SUBDIVISION COMMITTEE
METROPOLITAN AREA PLANNING COMMISSION

STAFF REPORT
(Preliminary Plat)

CASE NUMBER: S/D 89-68 - BILL BAILEY 2ND ADDITION

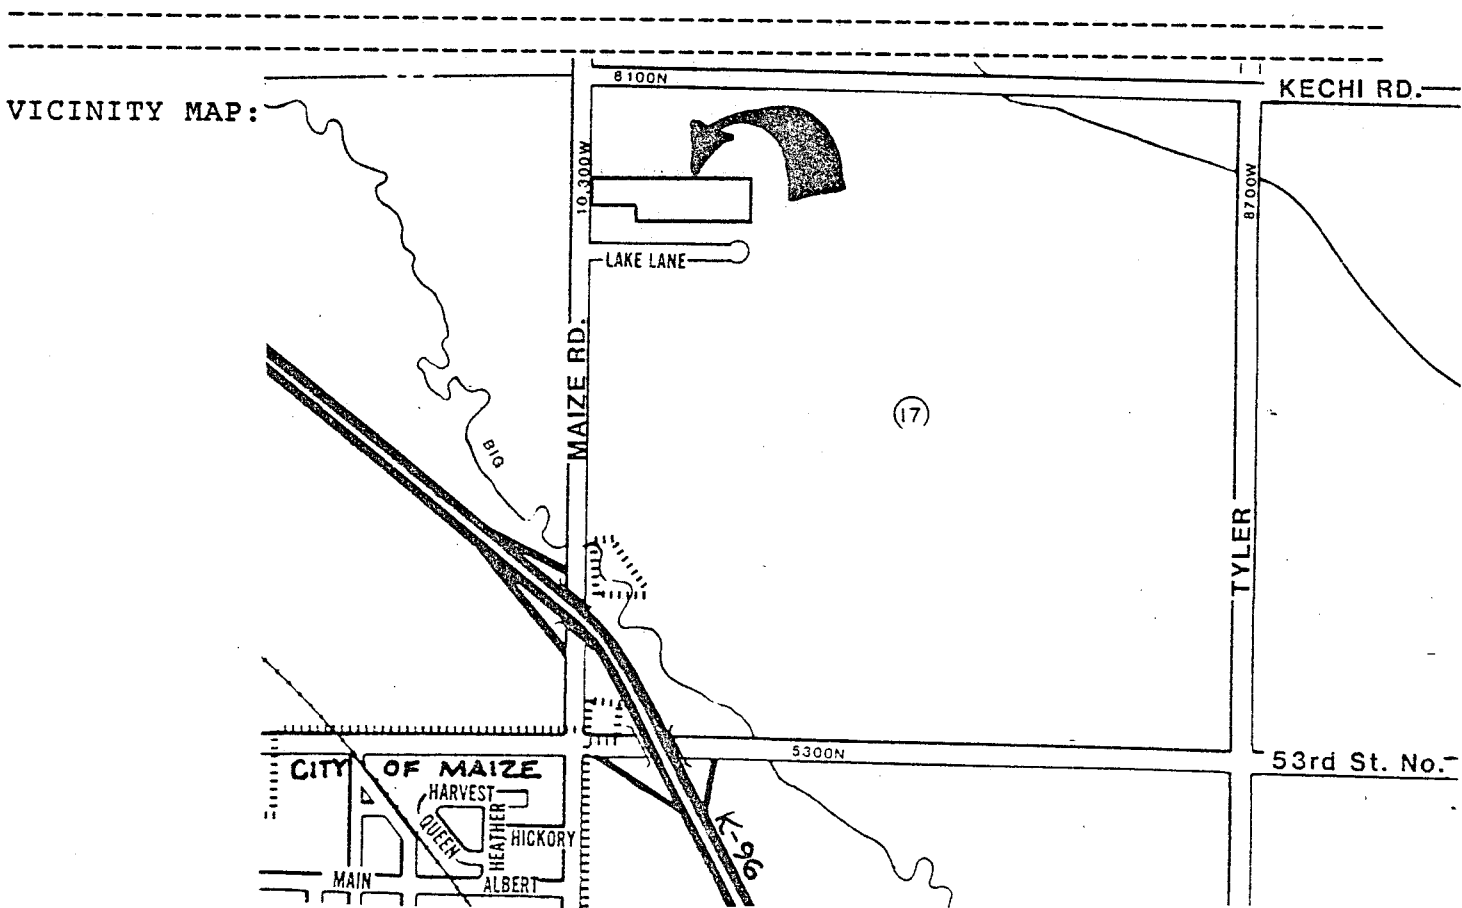
- A. In order to plat lots this size, the applicant must obtain "R-1" suburban residential zoning. An application for a zone change from "R" to "R-1" shall be submitted and approved prior to this plat being submitted to the County Commission.

- B. Since neither municipal water nor sanitary sewer is available to serve this property, the applicant shall contact the Environmental Health Division of the Health Department to find out what tests may be necessary and what standards are to be met for approval of on-site sewerage facilities and water wells. A memorandum shall be obtained specifying approval.

- C. The applicant shall guarantee the opening up of 60th Street North, including the temporary cul-de-sac, to suburban street standards.
- D. The applicant shall guarantee any drainage improvements required by the platting of this property.

- F. On the final plat complete access control shall be indicated to Maize Road from the west line of Lot 1, Block A. The plat's text shall state that the access control is being dedicated to the County.

- G. Lot 1, Block B shall also establish a 25-foot building setback to 60th Street. As indicated above and by the sketch plat, access to this site is by way of the proposed street. This setback maybe jogged around the existing pool.

- H. On the final plat tracing the cul-de-sac shall be indicated as temporary and the plat's text shall indicate that this temporary cul-de-sac will be vacated when 60th Street North is extended east.

- I. If required by the drainage plan, a floodway shall be indicated for this plat and the plat's text shall reference the standard floodway language.
- J. As required by section 8-103(1), the final plat shall indicate the placement of irons at all corner's of this subdivision. A legend shall be added to the face of the plat which identifies the irons set and the irons found.

- K. Prior to, or at the time of submitting the final plat, the applicant shall submit a drainage plan to County Engineering for review and approval.
